NOV_SCE_ATJ_ 20211118-01

NOTICE OF VIOLATION

Report Name: SCE_ATJ_20211118-01 Inspection Date(s): November 18, 2021 Inspector: Anthony Trujillo Utility: Southern California Edison Attention: Erik Takayesu, Vice President Asset Strategy and Planning

On November 18, 2021, I performed a walking inspection of Southern California Edison (SCE) covered conductor installations, 2021 WMP initiative number 7.3.3.3.1, along Tapo Canyon Road in the city of Santa Barbara, Santa Rosa Road in the city of Camarillo, and various locations in the city of Simi Valley, California. I was accompanied by Energy Safety Environmental Scientist Gary Candelas. Detailed findings from this field inspection are laid out in Section II below.

Structure ID: 4339409E

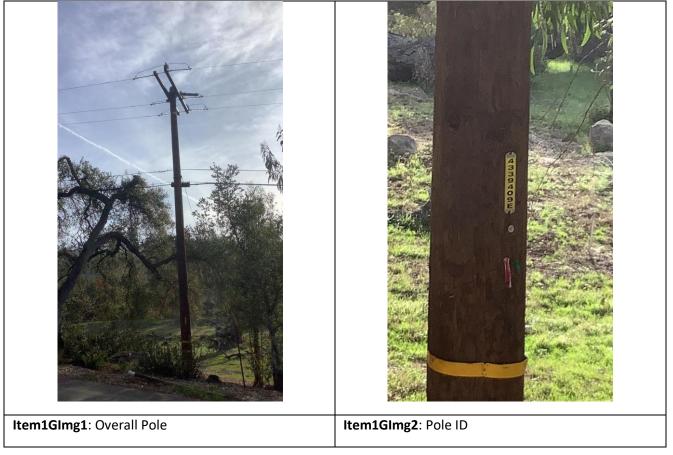
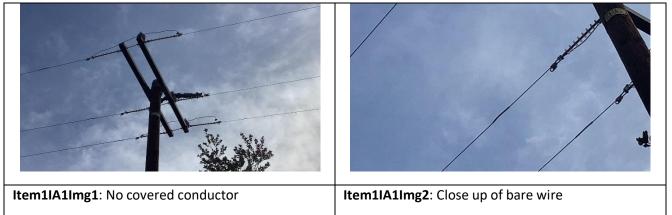
- Violation 1: Per SCE's 2021-Q1 quarterly data report (QDR), covered conductor was installed on poles numbered 4339409E, 4574184E, 4538061E, 4926384E, and 4263188E. All these structures reported a covered conductor initiative (2021 WMP initiative number 7.3.3.3.1) with a status of "Complete." However, upon inspection, SCE has not even begun covered conductor installation at any of these locations. Energy Safety considers this data accuracy violation to be in the Moderate risk category.

- 2. Violation 2: Per SCE's 2021-Q1 QDR, covered conductor was installed on poles numbered 4339409E, 4574184E, 4538061E, 4926384E, and 4263188E. Upon inspection, Energy Safety staff found no covered conductor installed at the above-mentioned structures. Given SCE's focus on covered conductor as one of its flagship wildfire mitigation programs and the scope of this mitigation program, Energy Safety is greatly concerned about how

ltem	Structure ID	HFTD	Defect Type	Severity	Defect Description
1	4339409E	Tier 3	Down guy wire loose	Minor	Loose guy wire
2	4926384E	Tier 3	Down guy wire loose	Minor	Loose guy wire

Structure ID: 1257280E

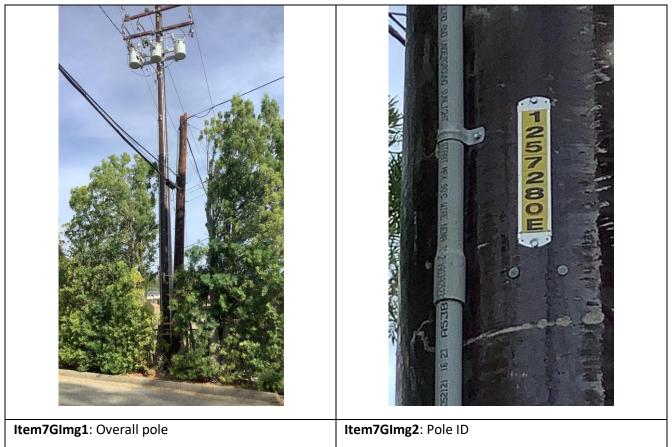
- 3. Violation 3: Per SCE's Distribution Overhead Construction Standards (DOH), section PO 300, page 3 of 9, and Distribution Design Standards (DDS), section DDS-10, page 10-26, installation of a fiberglass guy strain insulator is required for distribution guying applications and repairs in high fire risk areas (HFRAs) and shall be installed in conjunction with covered conductor installation¹. Poles numbered 1257280E, 4554703E, 4554704E, and 2144970E had covered conductor installed but failed to install fiberglass guy strain insulator, in accordance with SCE protocol. Energy Safety considers this violation for failure of adhering to protocol to be in the Minor risk category.
